UNITED STATES PATENT AND TRADEMARK OFFICE

APPLICATION NO.	FILING DATE	FIRST NAMED INVENTOR	ATTORNEY DOCKET NO.	CONFIRMATION NO.
10/500,505	06/29/2004	Nicasius G.T. Van Gennip	De 020005	4394

Office Action Summary

DETAILED ACTION

FIG. 1

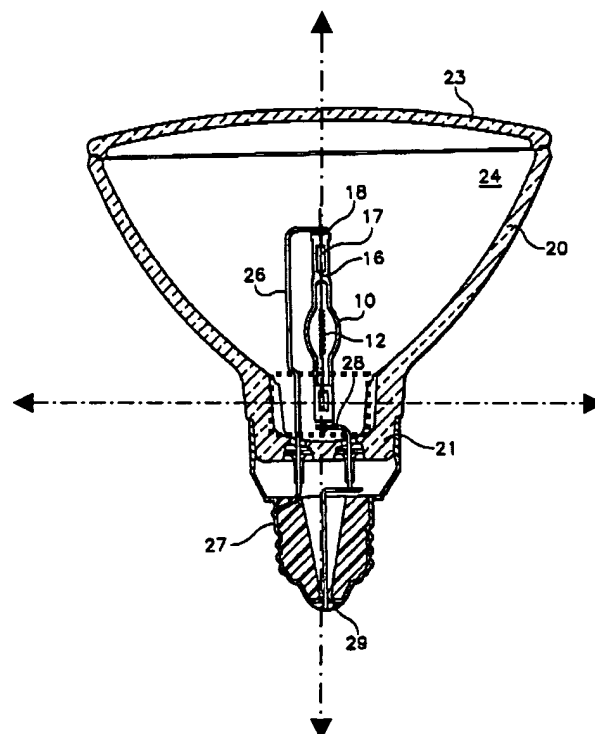
8. Claims 1-6 are rejected under 35 U.S.C. 102(b) as being anticipated by GIBSON ET AL. (US 6,049,169), which discloses:

- A discharge lamp for a motor vehicle (10);
- A return pole (26);
- A reflector and reflective surface (inner portion of 20 that guides/directs waves of light);
- A hollow reflector neck (lower portion of 20);
- An inner contour of reflecting surface having a rectangular shape with rounded corners and is x-axis asymmetrical and y-axis symmetrical (Fig. 1 below); and
- An asymmetrical burner centered in the reflector (10).
